Hydraulic Brake Interlock Circuit Protection

BULLETIN

Models Affected: Certain 2011-2013 Model Year Vision, With Hydraulic Brake Interlock

S E R V I C E B U L L E T I N

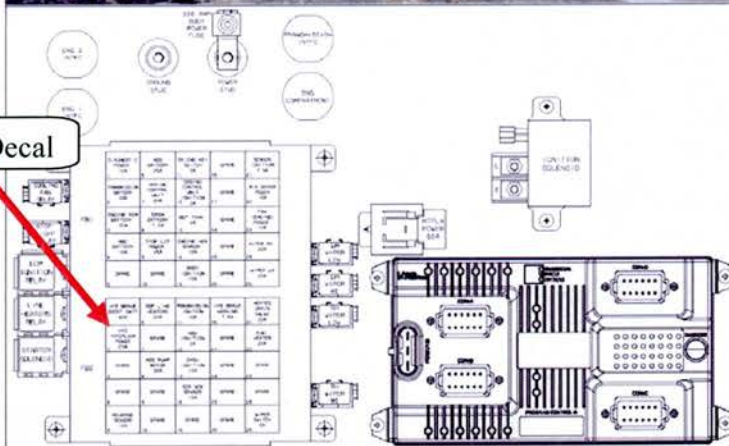
Certain 2011-2013 model year Vision buses equipped with hydraulic brake interlock feature may have incorrect circuit protection installed. This can lead to premature circuit breaker tripping.

Thumb screws.
Cover is located
lower center of
dash.

See Decal

Verify correct circuit protection installed. If required replace circuit protection. See the verification and replacement instruction below.

1. Park the bus on a level surface, apply parking brakes, turn off engine and remove keys. Chock wheels.
2. Remove chassis Power Distribution Unit (PDU) cover by removing two thumb screws. The thumb screws are located at the top of each side of the cover.
3. Verify fuse or breaker installed in fuse block (FB2) position (2). See decal on reverse side of PDU cover for location. It will be listed as "HYD INTERLOCK POWER". If a 25 amp fuse is installed no action is required, replace cover. If not a 25 amp fuse, replace with Blue Bird 25 amp fuse part number 01983832 and correct existing decal with the new overlay decal (provided).
